## **1618 Ararimu Road, Papakura: information request regarding ecological effects**

We refer to the Section 92 letters dated 6 December 2023 and 21 December 2023 from Marian Whitehead, Senior Planner at Auckland Council regarding Council's further information request for the development at 1618 Ararimu Road, Papakura as a managed fill operation, with associated enabling works.

To:	Laila Alkamil, Williamson Water and Land Advisory Ltd	Job No:	2307.100
From:	Emily Roper, RMA Ecology Ltd	Date:	3 July 2025
cc:	Graham Ussher, RMA Ecology Ltd		
Subject:	Ararimu Road culverts – Request for Further Information

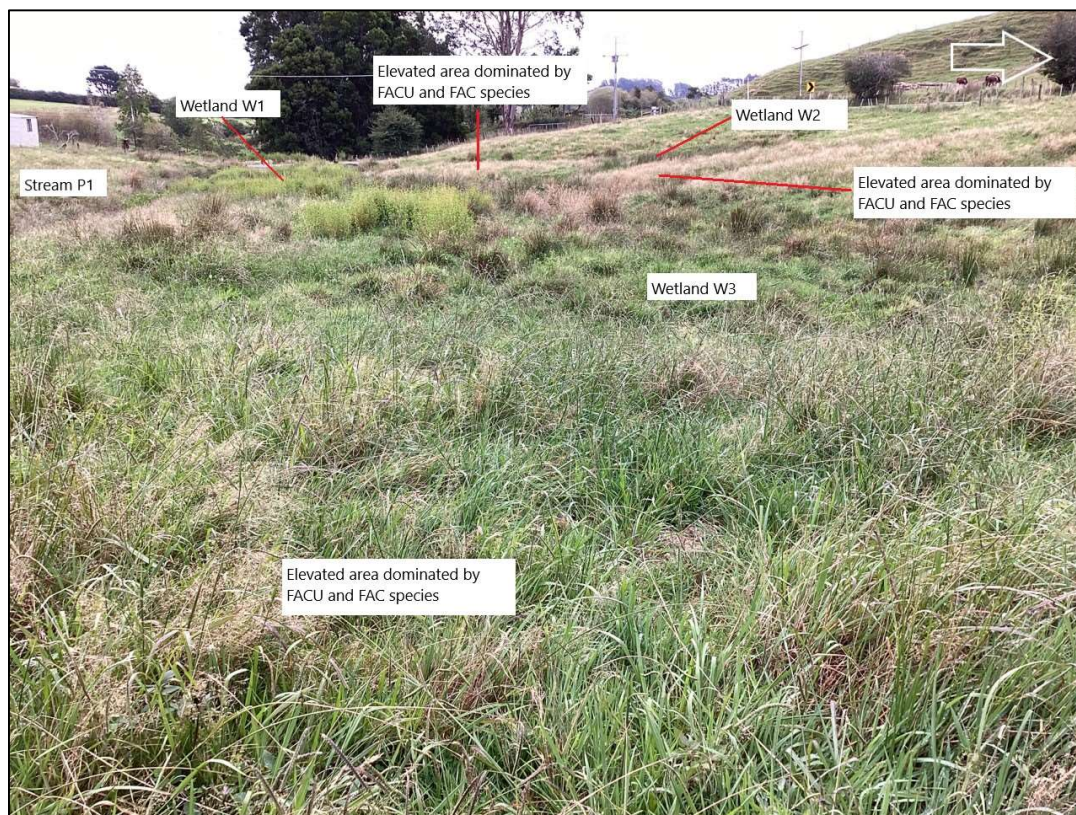
*In Section 3.3 of the EclA, the ecologist indicates that the MfE Pasture Exclusion Assessment Methodology was applied to potential wetlands on the site. Page 9 of this protocol (MfE, 2022) states the following "The purpose of the NPS-FM pasture exclusion clause is to support the continuing use of pasture for grazing purposes. The exclusion is not targeted at pasture being converted for urban development or for other land uses". Therefore, our interpretation is that areas that exhibit wetland characteristics, where land use will not remain grazed pasture, should be assessed following the method set out in the 2022 Wetland Delineation Protocol. In addition, areas that are subject to recent disturbance (including grazing) should be assessed, not only in terms of the vegetation modules of the protocol, but also in terms of hydric soil and hydrology.*

*Please advise the area and extent of wetlands on the site without the application of the Pasture Exclusion methodology. If necessary, please also revisit the calculation of offset targets.*

Areas immediately around these wetlands were not classified as natural inland wetlands for the following reasons, in addition to passing the Pasture Exclusion Test:

- These areas were assessed on site as being dominated by Facultative and Facultative Upland species, including *Paspalum dilatatum* (FACU) with a percentage cover of over 50 %, *Holcus lanatus* (FAC), *Plantago lanceolata* (FACU), *Trifolium repens* (FACU), and *Lotus pedunculatus* (FAC) (**Plate 1**). There were also occasional examples of *Juncus sarophorus* (FACW) but this species covered no more than 10 % of the area outside of the delineated wetlands. These areas did not pass the Dominance Test for vegetation and have a Prevalence Score of over 3.0.

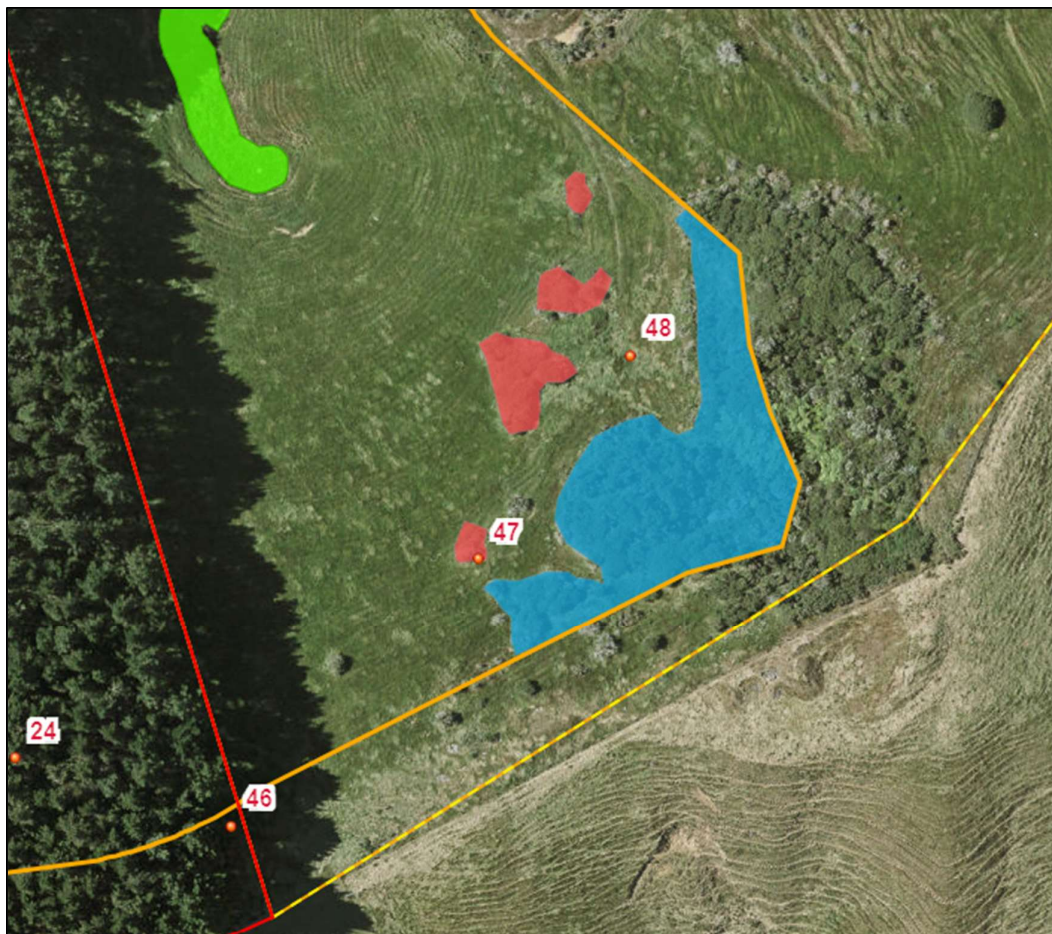
*Please review and update the AEE and EcIA to provide an assessment of the proposal in relation to Chapter E15 Vegetation Management and Biodiversity of the AUP(OP), particularly rules E15.4.1 (A10, A17) and (A18).*

Rule number	Rule	Activity status	Comment
			<p><i>Leptospermum scoparium</i>. 1,996 m<sup>2</sup> to be cleared – approximately half the area of an isolated patch of scrub in the south west corner of the proposed managed fill area (<b>Figure 3</b> below). The area to be cleared is primarily comprised of exotic <i>B. glaucocarpa</i> and <i>U. europeus</i> (<b>Plates 14 and 15</b>).</p> <p><u>Exotic scrub</u> (not indigenous) comprising patches of <i>B. glaucocarpa</i> amongst pasture grasses – 401 m<sup>2</sup> in total.</p>
<i>Riparian areas (as described below)</i>			
E15.4.1 (A17)	Vegetation alteration or removal within 10 m of rural streams in the Rural – Rural Production Zone and Rural – Mixed Rural Zone	Restricted Discretionary	<p>Vegetation will be removed within 10 m of Stream P1 for the development of the new access track, and for the excavation of material for wetland re-creation – approximately 930 m<sup>2</sup> of exotic pasture species.</p> <p>Vegetation will be removed within 10 m of the downstream section of Stream P2 for the earthworks required for development of the new access track – approximately 60 m<sup>2</sup> of exotic pasture species.</p> <p>Vegetation will be removed within 10 m of the central section of Stream P2 during the excavation required for wetland re-creation – approximately 2,300 m<sup>2</sup> of exotic pasture and other herbaceous species, a small number of the common native rush <i>Juncus sarophorus</i>, and 4-5 exotic willow trees (<i>Salix</i> sp.).</p> <p>Vegetation will be removed within 10 m of Stream I1 within the managed fill footprint – approximately 800 m<sup>2</sup> of exotic pasture species.</p> <p>The vegetation proposed for clearance is predominantly exotic and of very low ecological value. The areas that are to be cleared are all to be re-planted with native riparian/ wetland species, to a minimum width of 10 m on both banks of the streams, under the mitigation and offsetting proposals.</p>

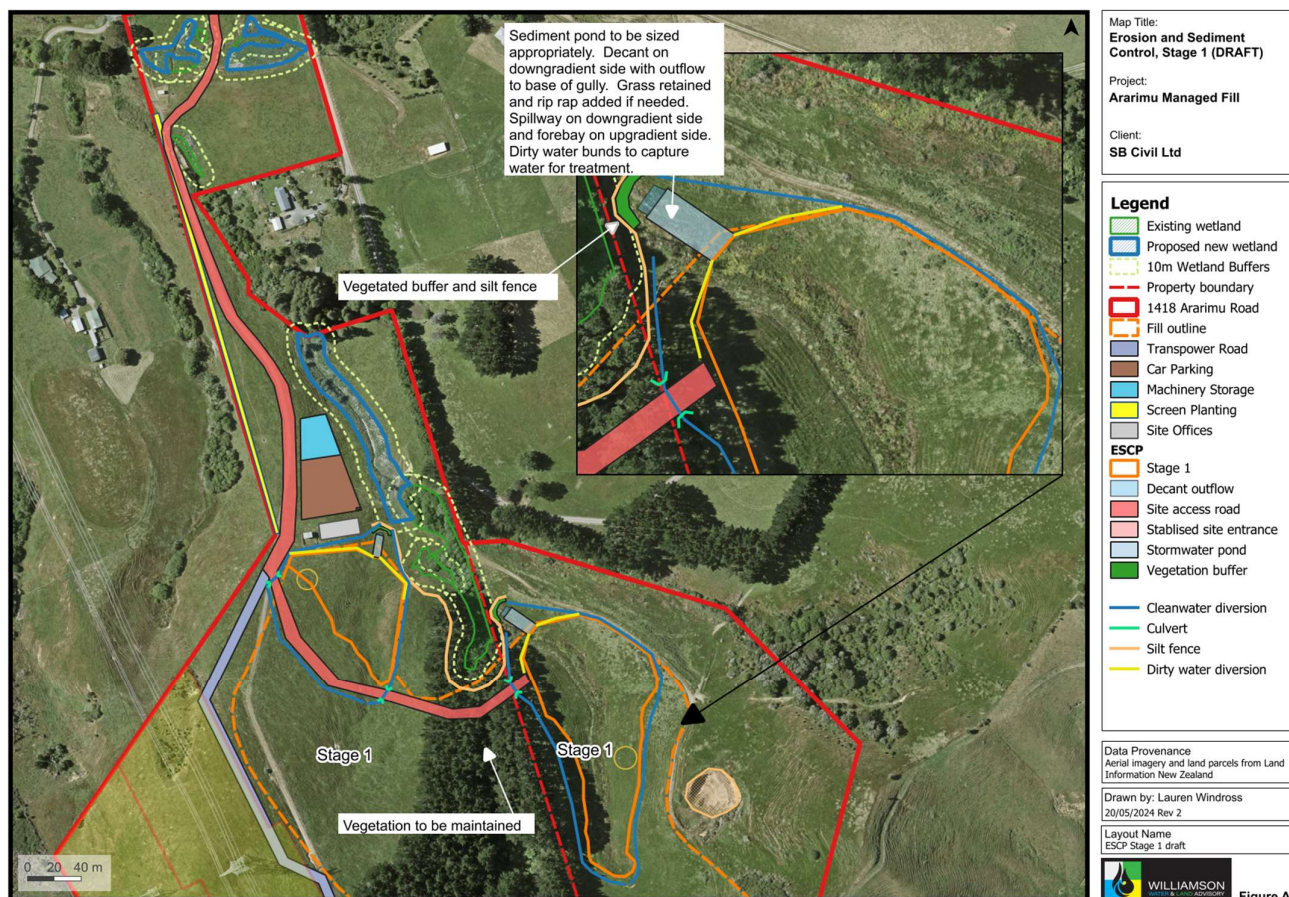
*Please provide Erosion and Sediment Control Plan(s) (ESCP) that include details that show the relationship with streams and wetlands including any protection mechanisms. This is vital in understanding how the streams and wetlands and associated riparian/ wetland vegetation will be protected during works.*

An updated ESCP has been provided – a copy of the plan is provided below. This shows the measures proposed and the relationship with streams and wetlands, which are:

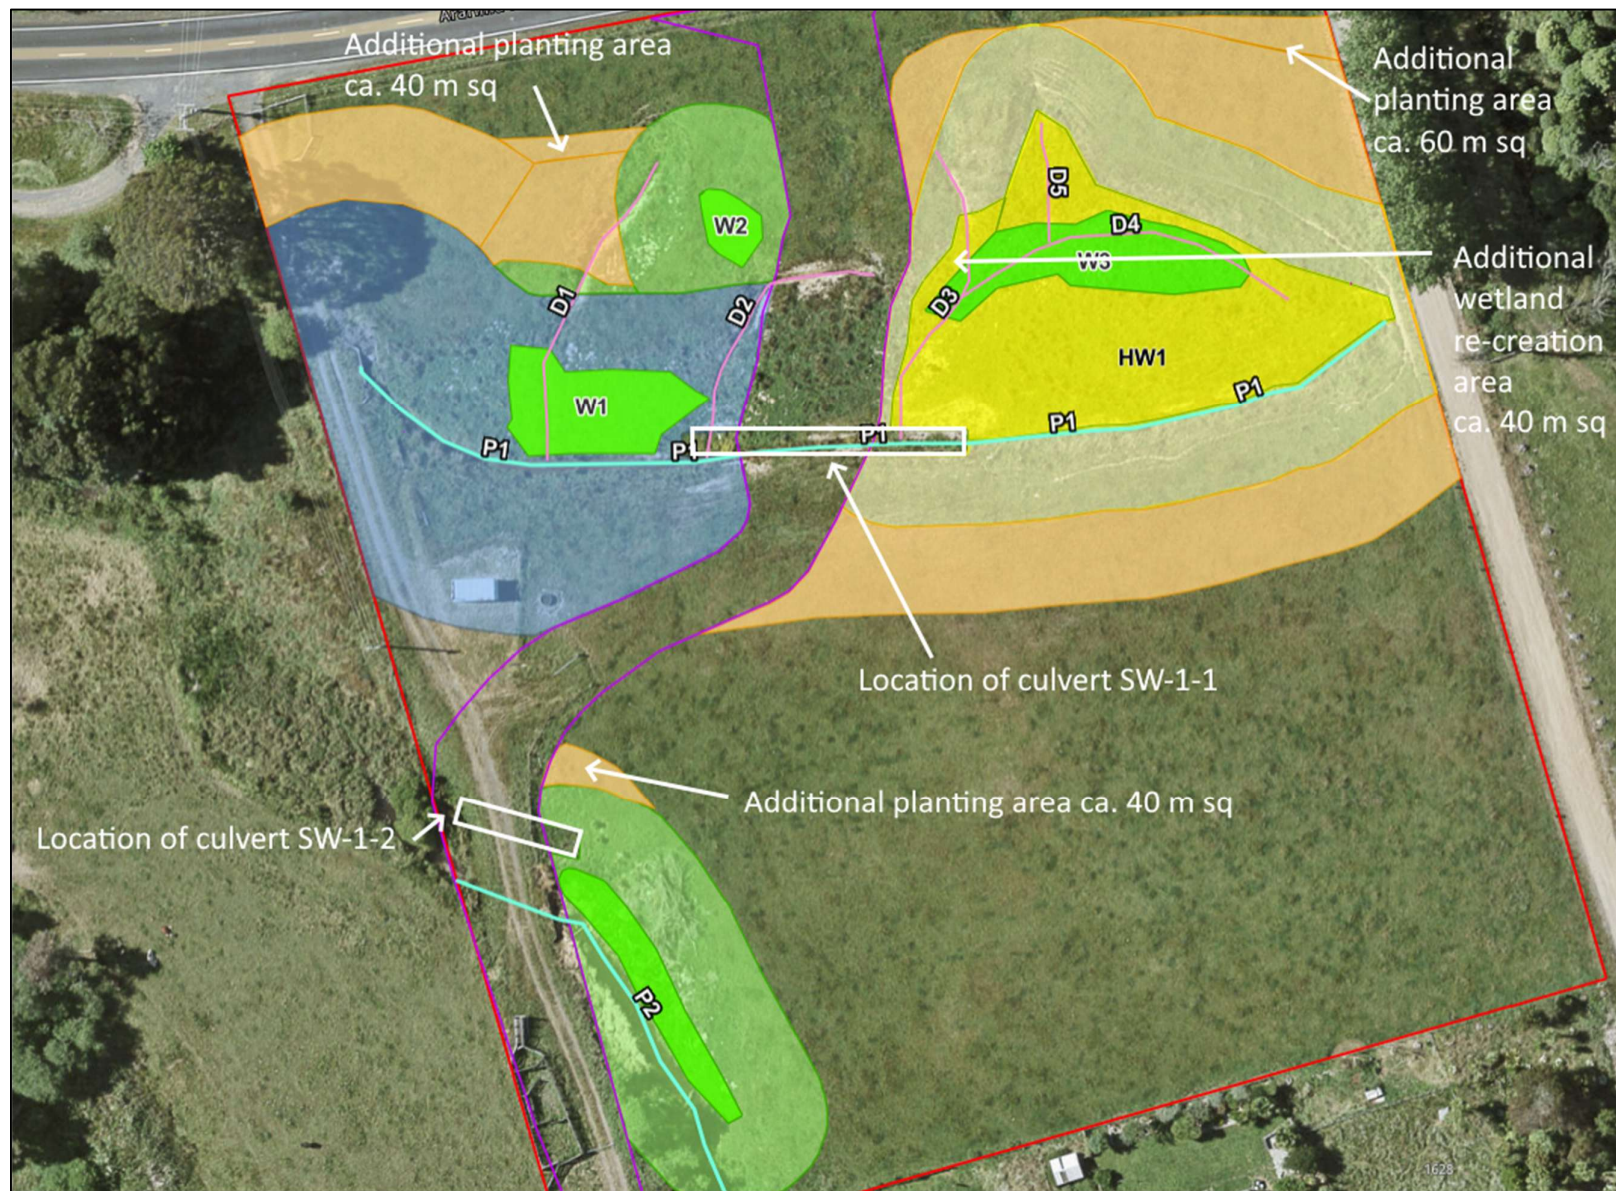
- Please confirm how the proposed offset plan will be affected by the proposed riprap and update calculations as required.

The proposed offset plan has been amended slightly to take into account those areas previously identified for mitigation or offset planting that will now be within the footprint of the culverts (**Figure 1**).

The footprint of culvert SW-1-1 will encroach into areas previously identified for stream offset planting and wetland re-creation and wetland buffer planting. The footprint of culvert SW-1-2 will encroach into the area previously identified for wetland and stream buffer planting. To ensure sufficient area for these plantings are maintained, additional areas for planting and wetland re-creation have been identified – see **Table 1** and **Figure 1** below.
